Realignment of a Portion of the Utah Lake Drainage Basin Water Delivery System Final Environmental Assessment

UTAH RECLAMATION
MITIGATION
AND CONSERVATION
COMMISSION

November 2010

Figure 2-5
Typical Construction Cross Section -
700 North/900 East/2200 North
Realignment of a ULS Pipeline - EA

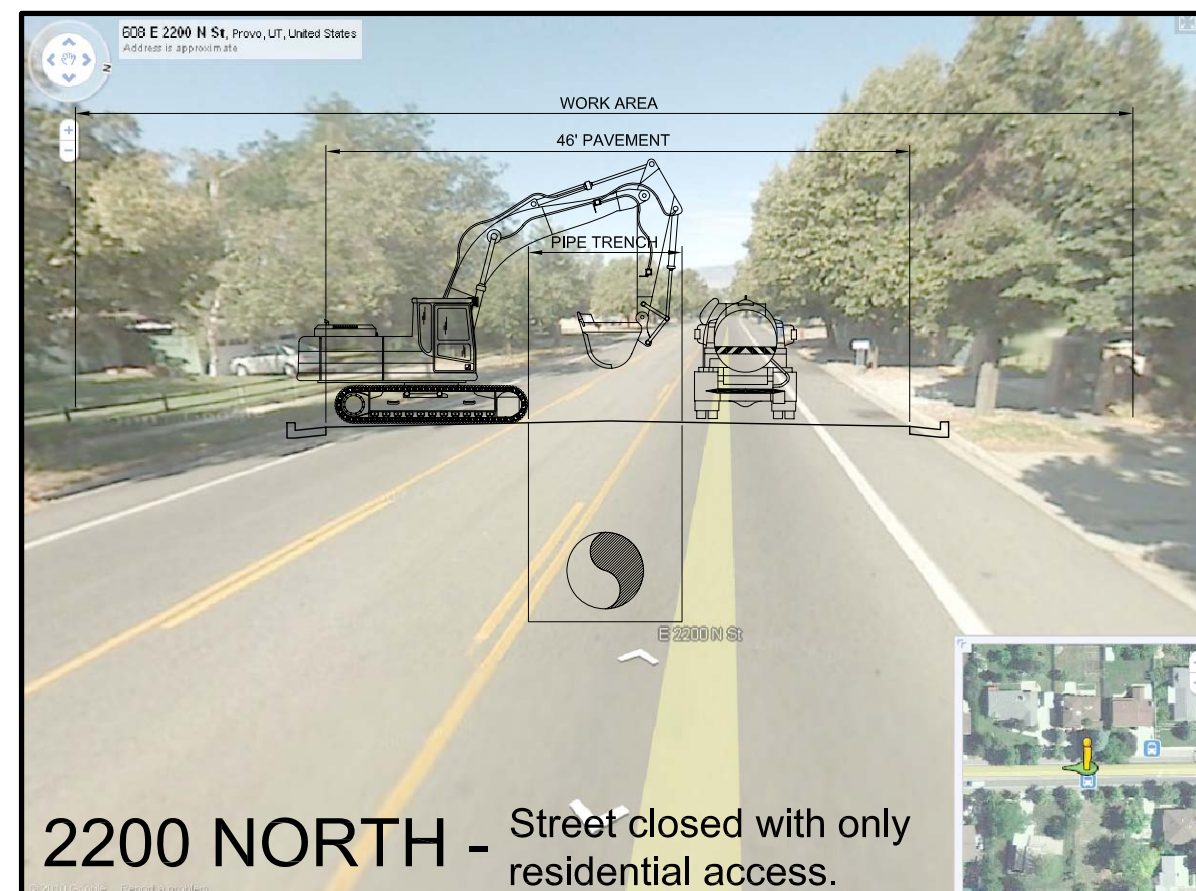
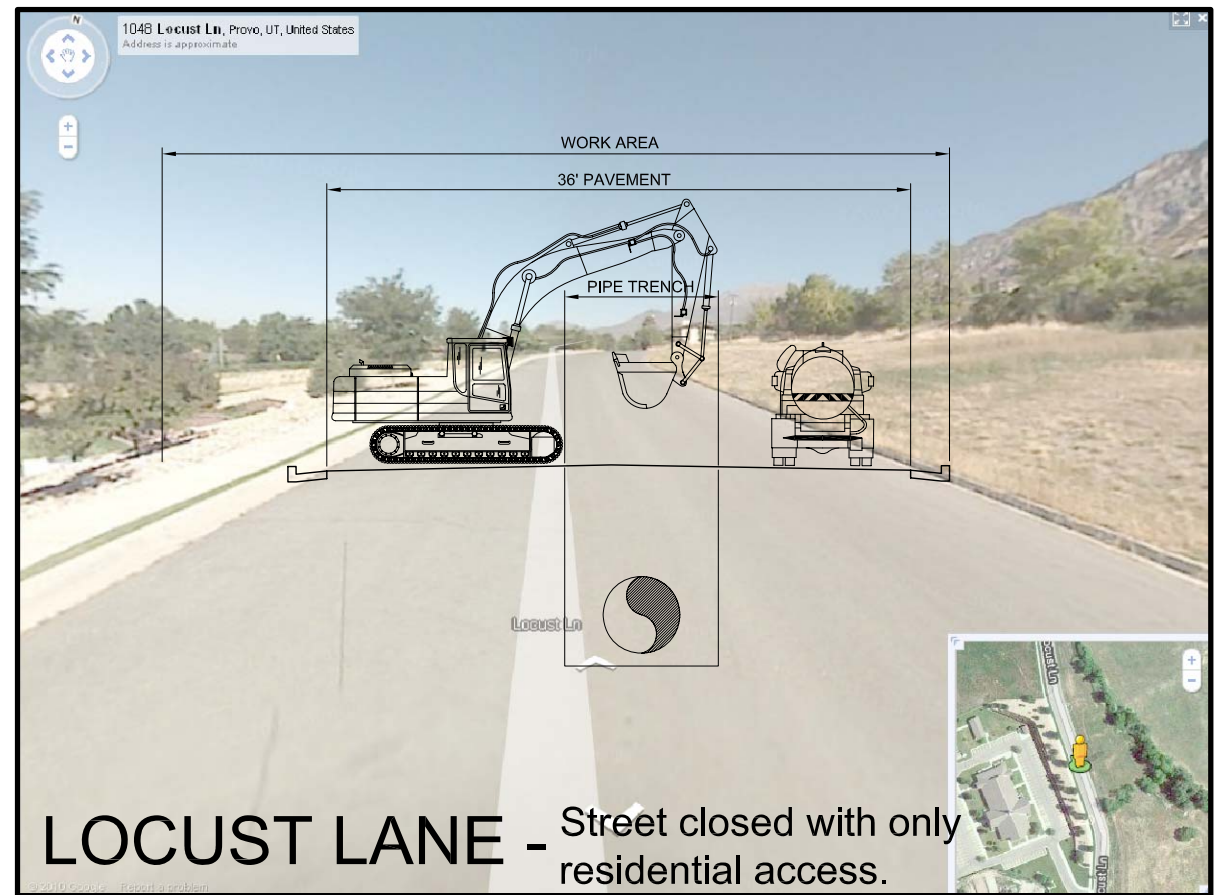
<i>Comment Number</i>	<i>Section</i>	<i>Comment</i>	<i>Response</i>
15	Figure 2-5	The cross section shown for 900 East does not accurately reflect where the work area would be in relation to the edge of pavement. The construction limit would need to provide a minimum of 26 feet from the lip of curb, in order to accommodate two travel lanes, construction barrels and a concrete barrier.	This figure has not been modified based on this comment. The figure is only a representation of what construction may look like in various locations. It is not meant to indicate finite locations or widths of various work zone and traffic lane components.
16	Section 3.2 and Appendix B	<p>In general, the Technical Report, which was put together to analyze construction traffic impacts for the proposed project, has some significant flaws. Very little or no coordination of the information included in this report has occurred with Provo City. Environmental capacities have been established by the City for all of the different street classifications within Provo. This report has not used these standards; but has instead used national standards, which significantly underestimate the impacts which the project will have on Provo City streets. The analysis should be redone to be consistent with lane capacity standards adopted by Provo City.</p> <p>The report also spends considerable time justifying average delays which will be caused by the project. Instead, the report should accurately estimate the maximum impacts which can be anticipated as a result of the project. The report further indicates that the LOS (Level of Service) which could be expected during the construction project would be almost the same, and in some cases better than currently exists. This is not only unreasonable, but makes no sense, considering many streets are proposed to include lane restrictions and/or full street closures.</p> <p>We would suggest that the traffic analysis be modified to include the general information which addresses these issues, and that the consultant closely coordinate this activity with Provo City. We are interested in having the traffic impacts clearly defined, and that the report include recommendations for mitigation of traffic impacts associated with project construction.</p>	The traffic memo is used to develop information for the EA. Additional modeling can be done during the design phase prior to construction.
